**Title: Combined Stage 1&2 Road Safety Audit
For;
Rathgowan Housing Development, Co. Westmeath.**

Client: PUNCH Consulting Engineers

Date: May 2022

Report reference: 1497R01

Drawing 202215-PUNCH-XX-XX-DR-C-0460 – C03, Corner radii.

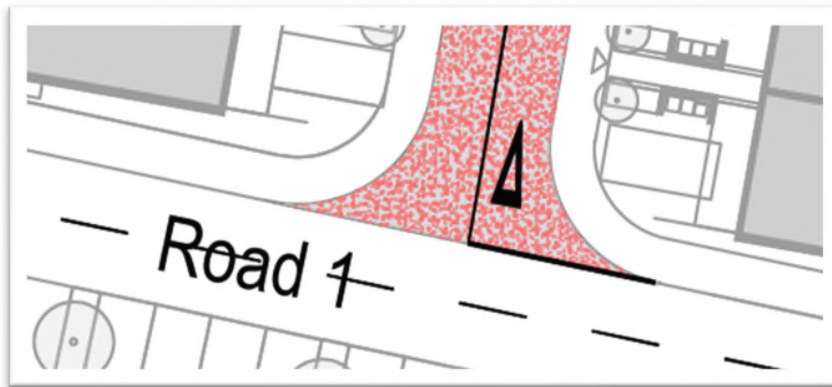
Some of the corner radii at homezones and other local streets appear to have relatively large corner radii. This could lead to higher turning speeds, greater distances for pedestrians to have to cross and greater risk of cyclists being in the blind spot of turning vehicles.

It is recommended that corner radii be minimized in line with the guidance provided in DMURS.

Drawing 202215-PUNCH-XX-XX-DR-C-0460 – C03, Spur road off Road 3.

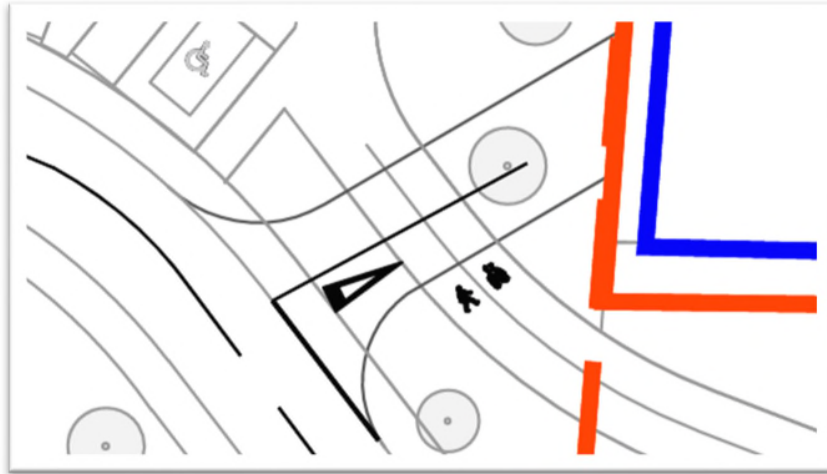
There is a spur road off Road 3 which is presumed to be able to serve possible future development. It is unclear if the road or the cycle track and footpath which cross it will have priority. A lack of clear priority would lead to collisions.

It is recommended that the footpath and cyclist crossing be raised and provided in a different colour surfacing to the carriageway so that approaching drivers will know to beware of oncoming cyclists and pedestrians.

Drawing 202215-PUNCH-XX-XX-DR-C-0460 – C03, perpendicular parking spaces along Homezone 1 and other roads.

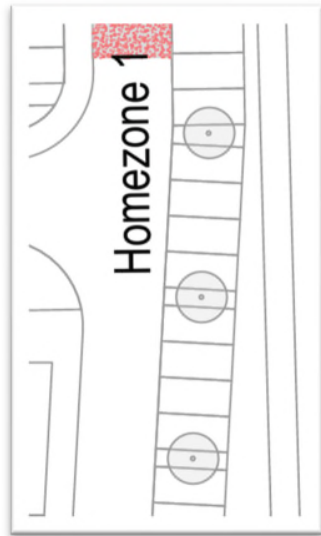
It is unclear if there is sufficient space for drivers to enter/egress from the perpendicular parking spaces on homezone 1 due to the narrow carriageway width. A lack of space could lead to material damage of other vehicles. There is also a lack of space for larger or emergency vehicles to turn at the ends of Homezone 1.

It is recommended that a swept path analysis be carried out to ensure that the parking manoeuvres can easily be carried in Homezone 1 and other similar dimensioned areas. Guidance on carriageway width/parking space width/buffer zones is provided in DMURS. Turning heads should be provided at the ends of the Homezone to avoid excessive lengths of reversing manoeuvres.

Drawing 202215-PUNCH-XX-XX-DR-C-0460 – C03, R494 toucan crossing

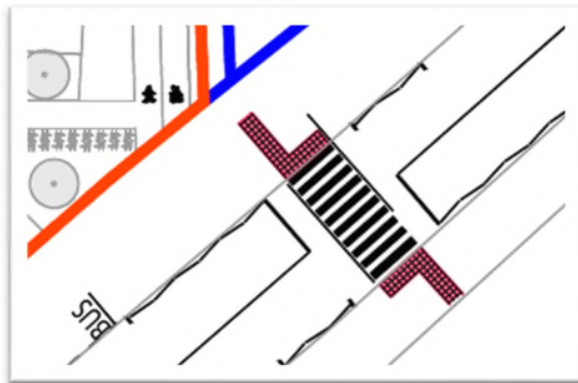
It is proposed to provide a toucan crossing on the R394. The cycle lanes on the R394 are however on-road. There are no facilities for cyclists to access the push buttons. This could lead to collisions with passing vehicles and waiting cyclists.

It is recommended that the on-road cycle lane be split onto a shared use area with suitable tactile paving at both sides of the toucan crossing.

Drawing 202215-PUNCH-XX-XX-DR-C-0460 – C03, R494 toucan crossing.

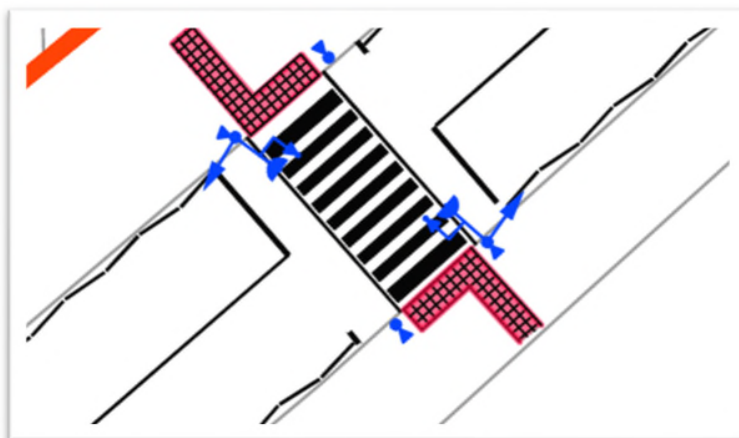
It is proposed to provide only primary signal heads at the toucan crossing. A driver's visibility may be obscured to the single head by a high-sided vehicle or bus and this may lead to failure to stop when pedestrians or cyclists are crossing.

It is recommended that secondary signal heads be provided.
